**HUNTLEY COMMUNITY SCHOOL DISTRICT 158**  
**Addendum No. 3 to the Specifications for Roof Systems Replacement and Repairs BID# 2017-68**  
3/16/17

**Addendum No.2 Items**

Roof Replacement Project:  
 Consolidated School District #158  
 Martin Elementary  
 10920 Reed Road  
 Lake in the Hills, IL 60156

## 6" - 'K' STYLE GUTTER DETAIL

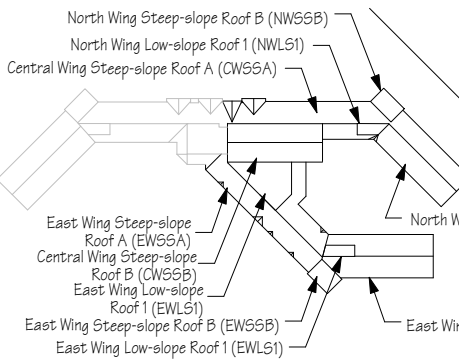
1. The Detail of the Gutter on Detail A/D1 is revised as shown on detail with this addendum.
2. Drawing # RP7 is revised as attached to this addendum.

**This detail is a revision to the gutter detail shown in detail A on drawing D1**  
 2 - 3" X 4" Down-spouts required on each Shed Roof

**Sheet Number:**  
 RP-7

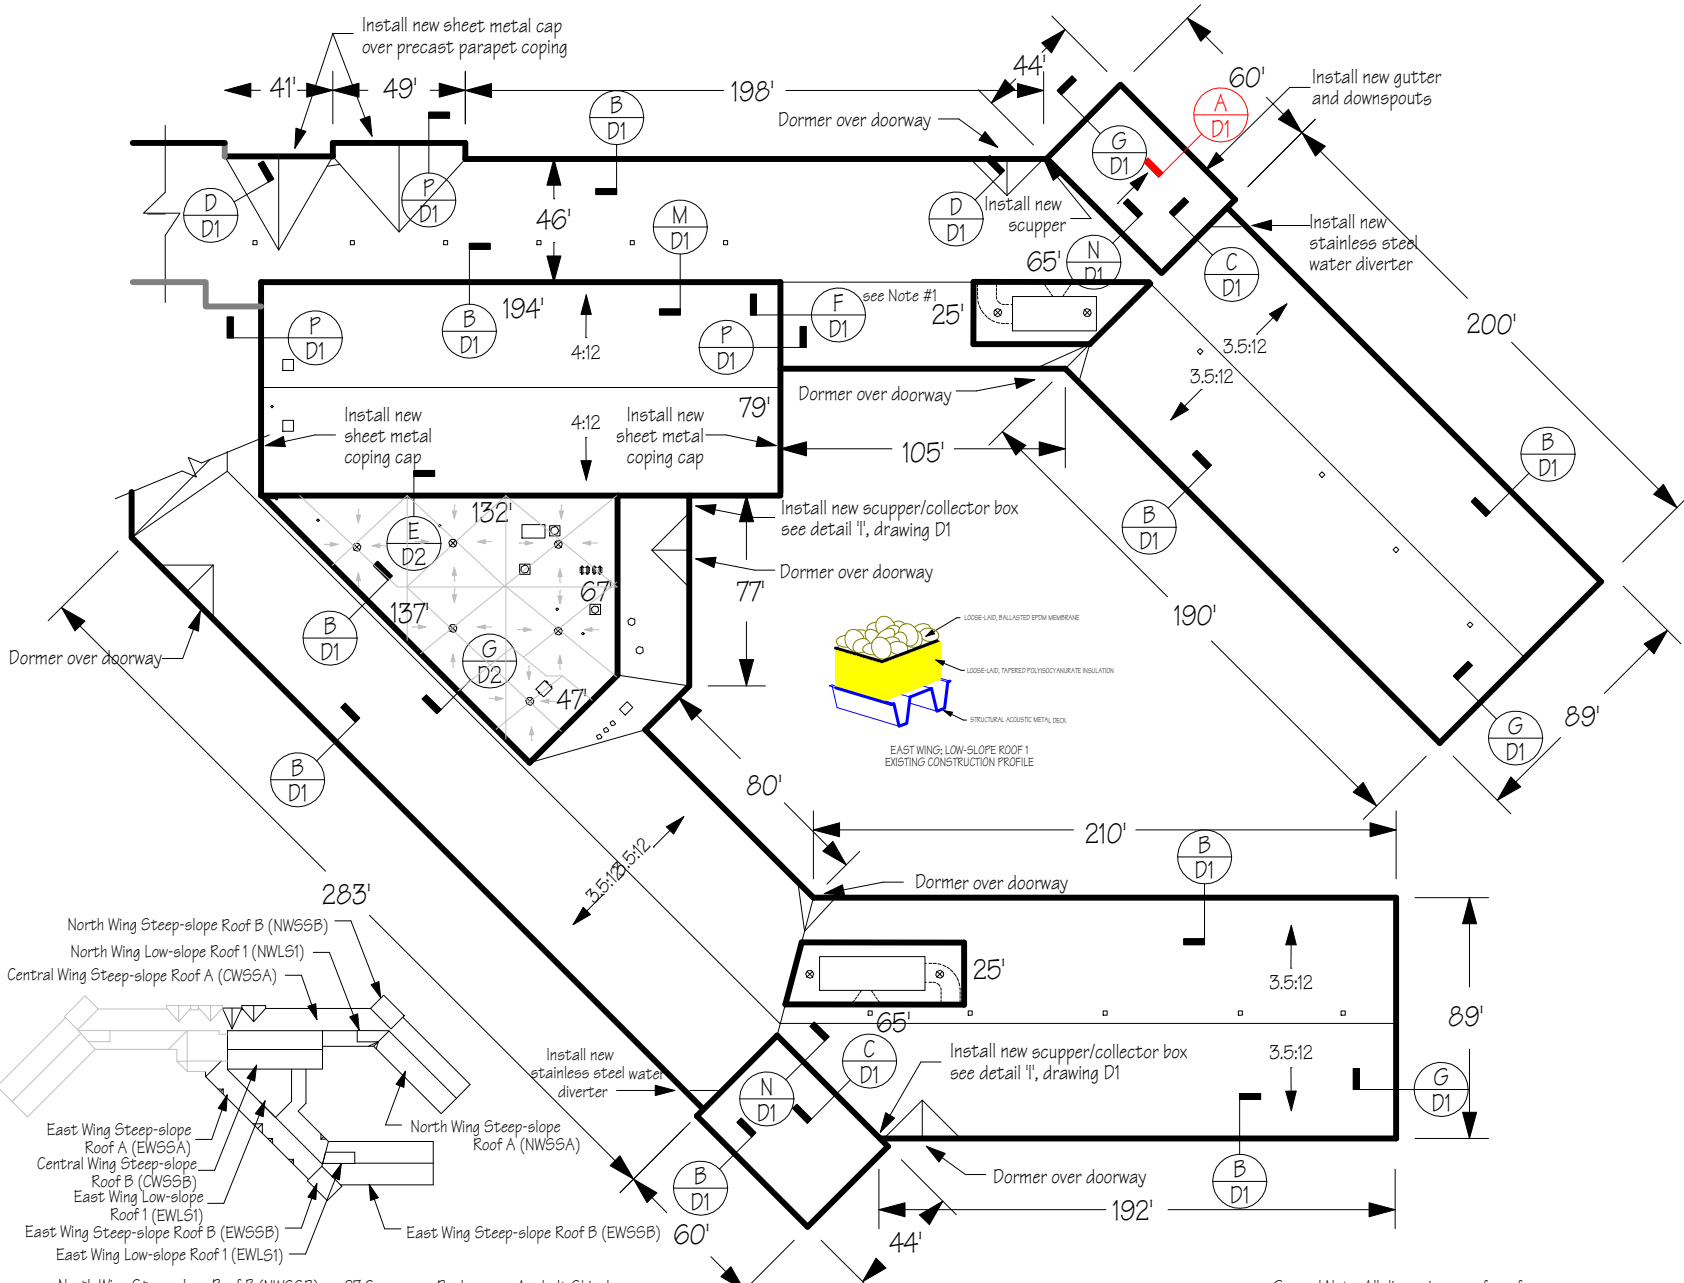
General Note: All dimensions are for reference. Bidding contractors have sole responsibility for verifying and submitting bids based on the accuracy of their measurements.  
 Note #1: No New Sheet Metal Required at this Location
